TECHNICAL NOTE

DATE:	24 January 2020	CONFIDENTIALITY:	Public
SUBJECT:	A49 VISSIM Model Review		
PROJECT:	Peel Hall	AUTHOR:	MJ
CHECKED:	TL	APPROVED:	CEW

WSP have been commissioned by Warrington Borough Council to provide technical advice regarding transport modelling for a development site at Peel Hall. As part of the development assessment a 2019 base Vissim microsimulation model of the A49 Corridor between A49 Winwick Link Road/Newton Road/ Winwick Park Avenue Junction and A49/ Retail Park Junction plus the M62 mainline at junction 9 has been constructed. A high level model review has been undertaken to assess the model validity and fitness for purpose. The findings are detailed in this Technical Note.

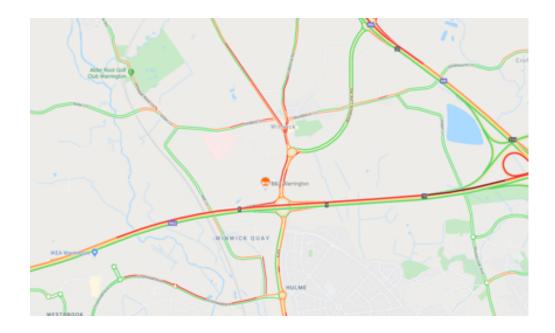
a. Google Traffic shows long delays on M62 eastbound mainline and the eastbound off-slip road in the AM peak, as shown below. However, the model does not really replicate the queues. We are aware that there are currently roadworks on the M62 in this area for the implementation of smart

motorways and therefore the local authority may be able to comment further on if this level of congestion is typical or just a product of temporary traffic management. **See summary**

- In response to the over-arching comments regarding levels of queuing and delay this was never a full model build and validation exercise, and hopefully isn't being audited as such. A best attempt was made firstly just to check that the model operation itself seemed reasonable, which it broadly was.

- As the model was provided as a previously approved model by Highways England, things like the level of delay caused by elements external to the model (i.e. M62 eastbound) were left as per the original modelling.

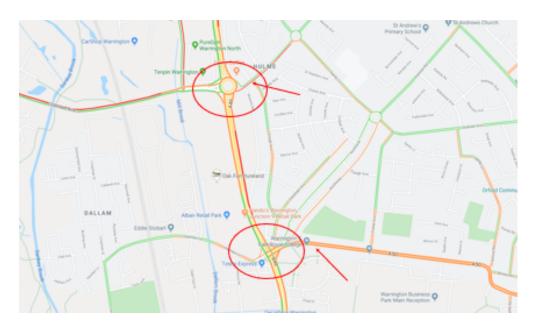
b. In both AM and PM, A49 Winwick Road/ A574 Cromwell Avenue/ Sandy Lane West Junction and A49 Winwick Road/ Nine Retail Park Junction are quite congested all through the peak times. The modelled queues are much shorter on Sandy Lane westbound and the A50 Long Lane westbound. These two roads along with M62 J9 are the main exits for vehicles generated by the proposed new development that this model will support so it is recommended to review the level of queuing and delay on these links in comparison to observed conditions because no journey time or queue comparison is currently included outside of the A49 corridor. See summary

- Equally, in regard to the note about delays on entry links such as Sandy Lane etc there is no data to suggest a need to change the original network coding, and the volume and journey time calibration has been fairly balanced considering it is made up of hybrid sources it can only be assumed that any additional delay showing up on Big Data sources such as Google Traffic must be resultant of different/ additional/ suppressed traffic demand. As all future year testing will have its demand drawn from an approved strategic traffic model of the area, this seems to be a moot point in any event.
